APPLICATION NO.	FILING DATE	FIRST NAMED INVENTOR	ATTORNEY DOCKET NO.	CONFIRMATION NO.
10/731,445	12/10/2003	Hye Yong Park	K-0589	5122
34610	7590	10/18/2005	EXAMINER	
FLESHNER & KIM, LLP P.O. BOX 221200 CHANTILLY, VA 20153			NELSON, JAMES T	
			ART UNIT	PAPER NUMBER
			3637

Office Action Summary	Application No. 10/731,445	Applicant(s) PARK ET AL.	
	Examiner James T. Nelson	Art Unit 3637

DETAILED ACTION

Sakamoto
Fig. 1

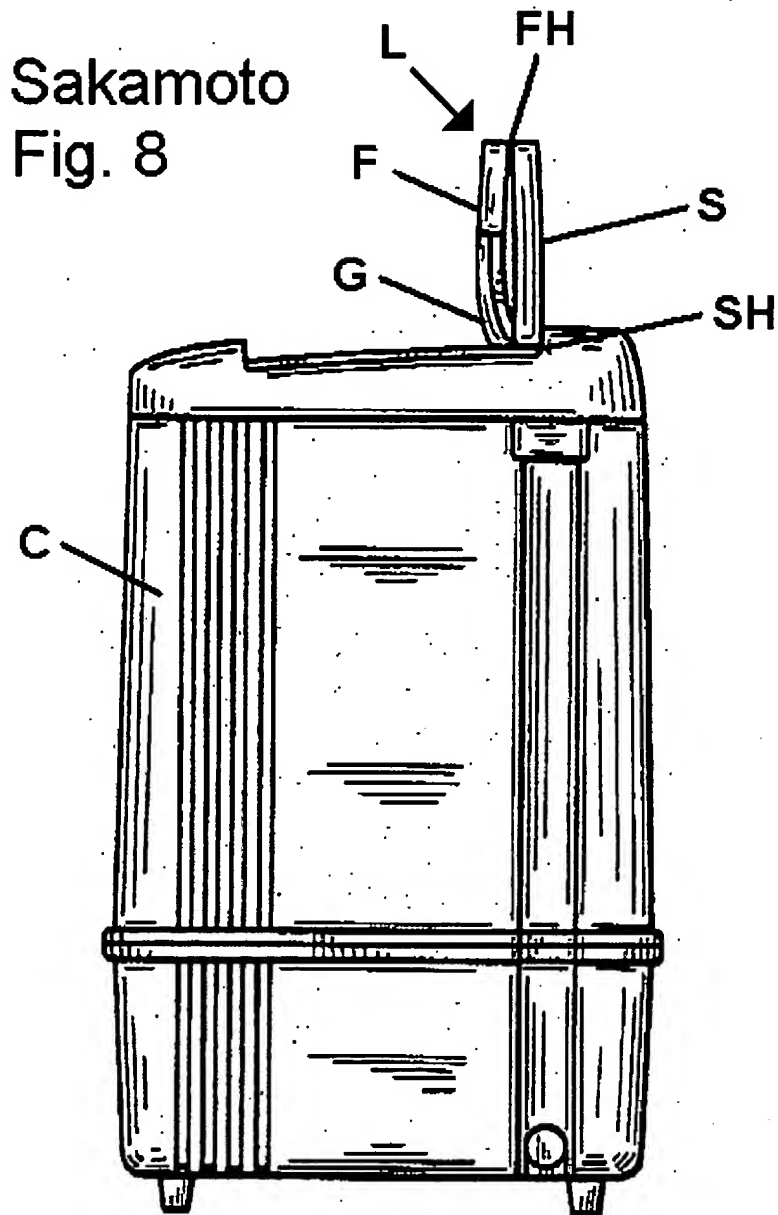
8. Claims 12-14 are rejected under 35 U.S.C. 103(a) as being unpatentable over Sakamoto (U.S. Design Patent 313,679), in view of Ford (U.S. Patent 4,638,909). In Figs. 1 and 8, Sakamoto shows a cabinet of a home appliance (C) having a sectioned lid (L) comprising a first section (F) and a second section (S) having one end hinge-coupled (FH) to the first section (F), wherein the other end of the second section (S) is hinge-coupled (SH) to the cabinet of the home appliance (C) and wherein the first section (S) comprises a grip (G). Sakamoto lacks an outer panel having at least one reinforcement rib, internally formed on an inner surface of said outer panel, to protrude from the inner surface to a predetermined height; and an inner panel having at least one boss, formed on an inner surface of said inner panel in opposition to the at least one
